MONITORING YEAR 4 ANNUAL REPORT

LITTLE PINE III STREAM AND WETLAND RESTORATION PROJECT

RE: Monitoring Year 4 (MY4) Report – Final Submittal
Little Pine Creek III Mitigation Site
DMS ID 94903
DEQ Contract Number 6844
New River Basin - #CU# 05050001 - Alleghany County, North Carolina

Figure 3.1 - Current Condition Plan View Map (Sheet 1)
Little Pine Creek III Stream & Wetland Restoration Project
DMS Project No. 94903
Monitoring Year 4 - 2019
Alleghany County, NC

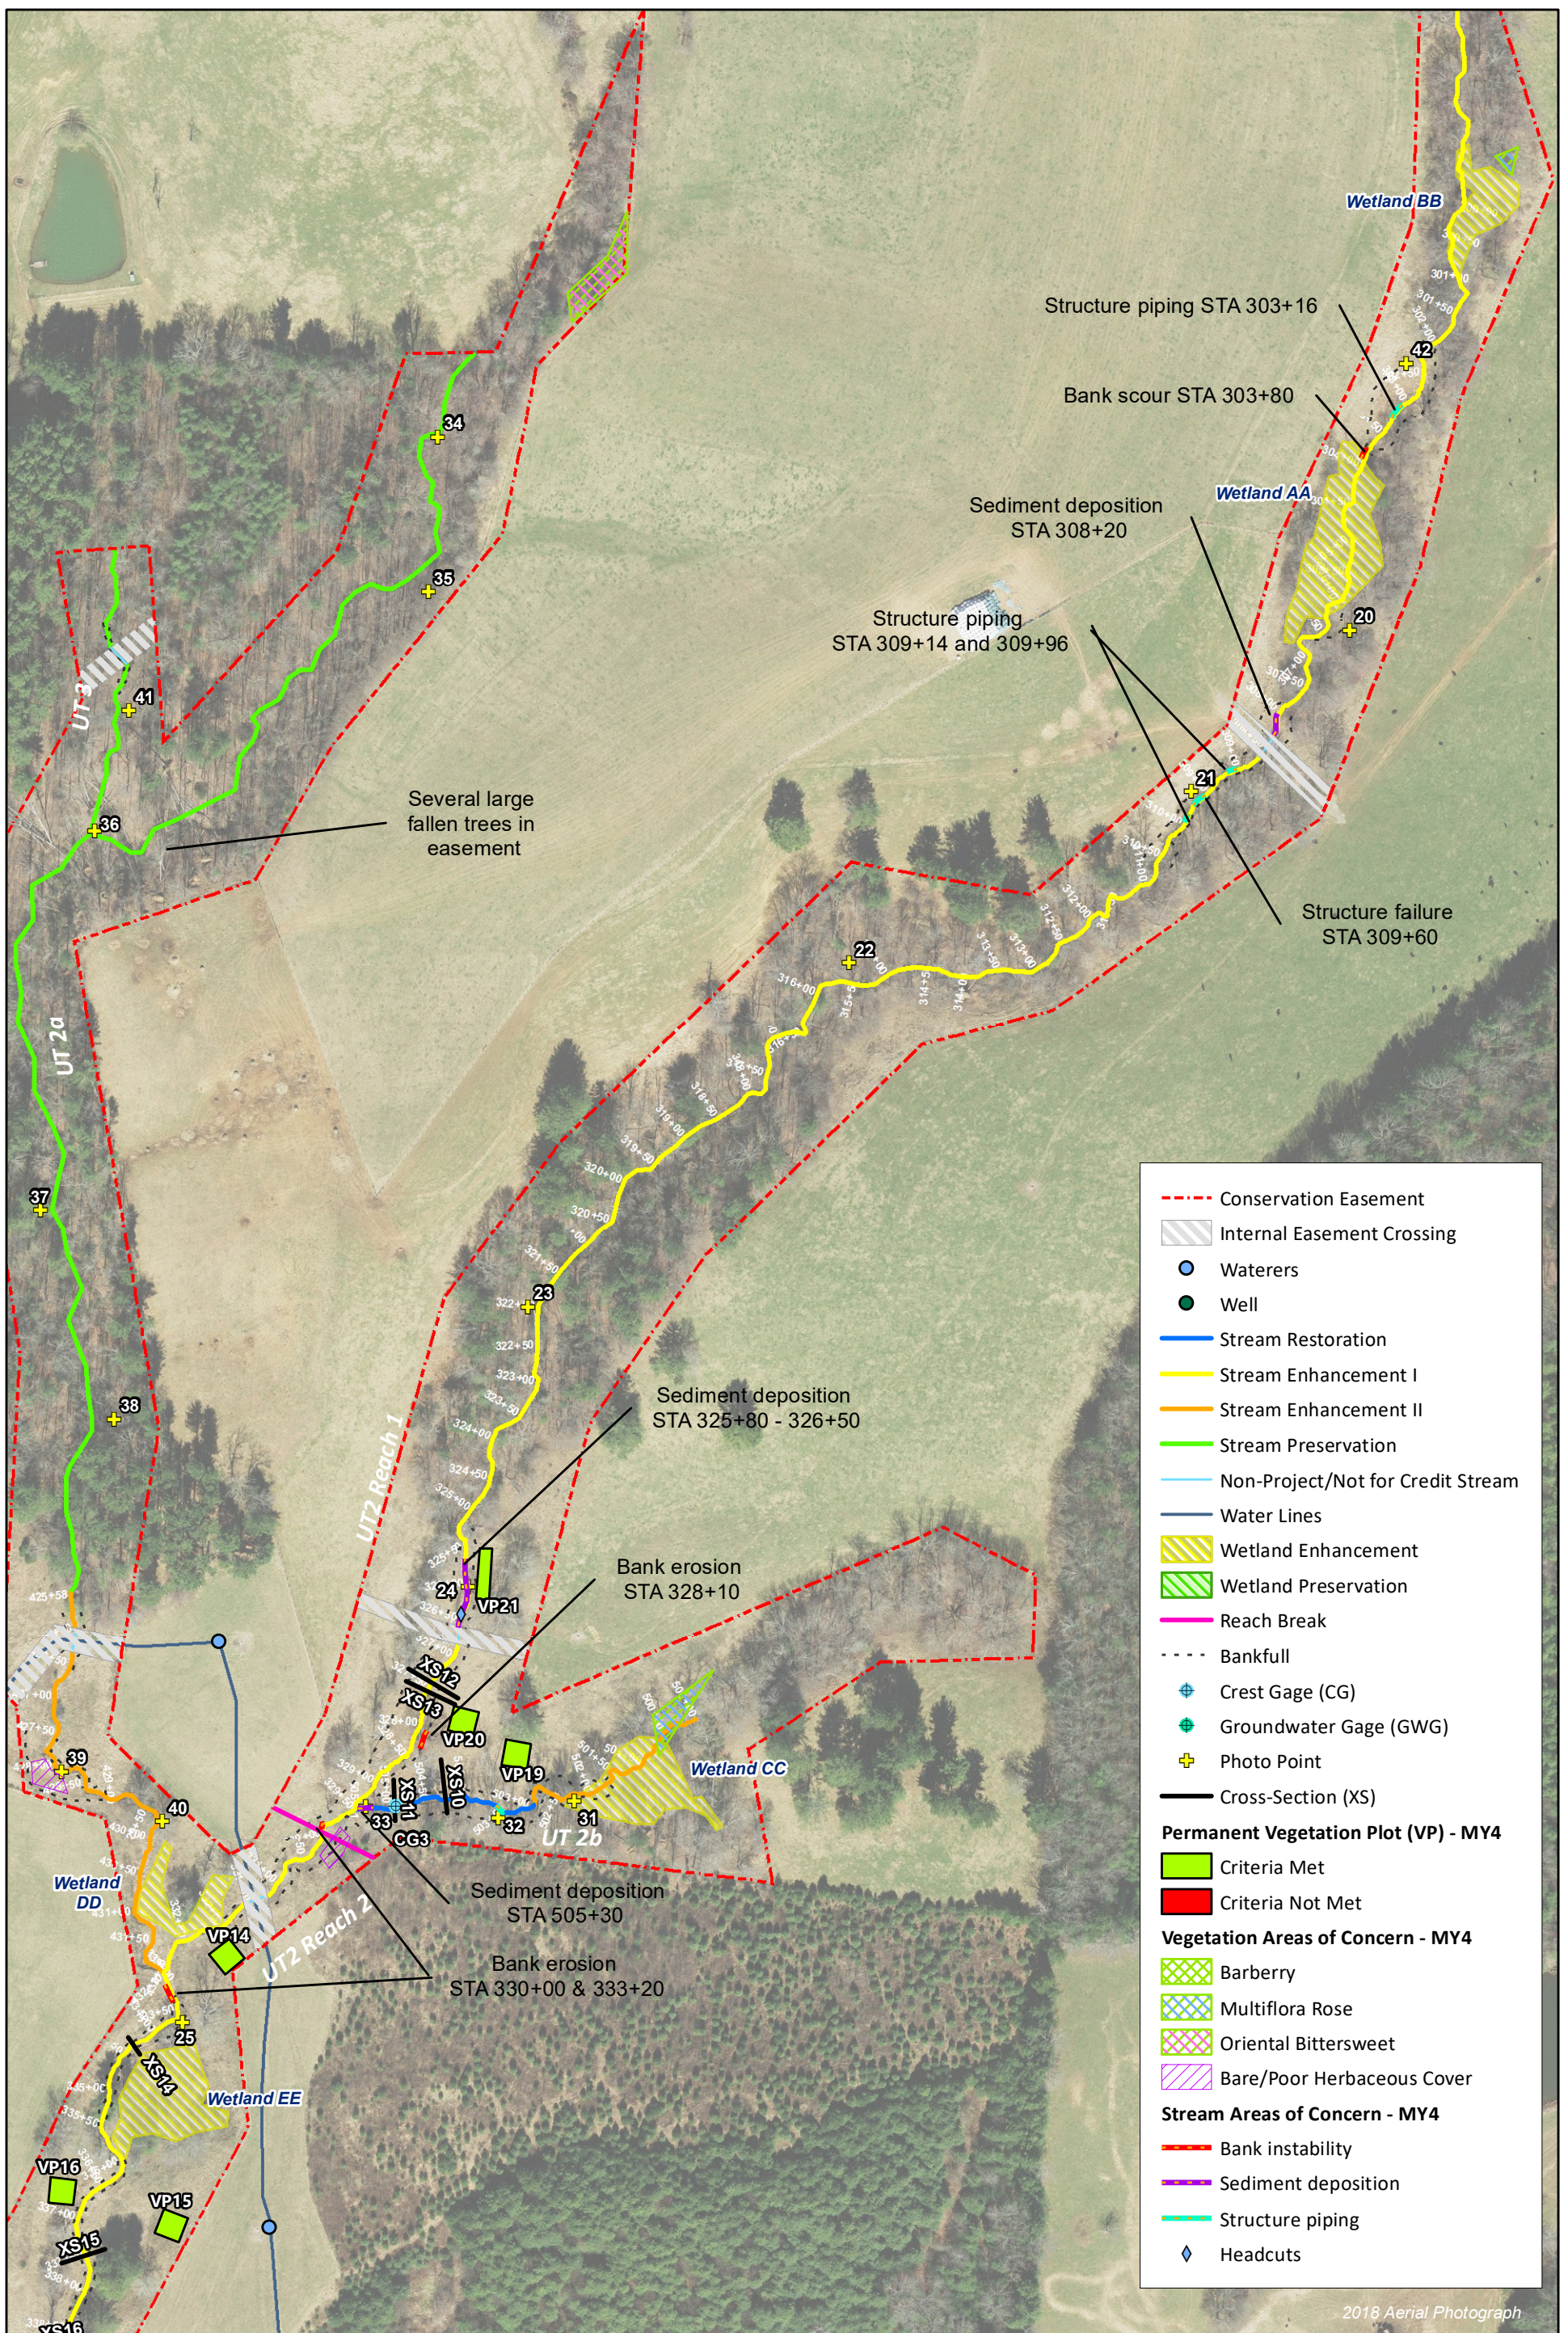
DMS comment; Can the two boulder sills (referenced in regard to upstream sediment deposition and the stream gage location) on UT1 be mapped or called out on the CCPV?

Wildlands response; A callout has been added to the CCPV to note the location of the two boulder sills on UT1.
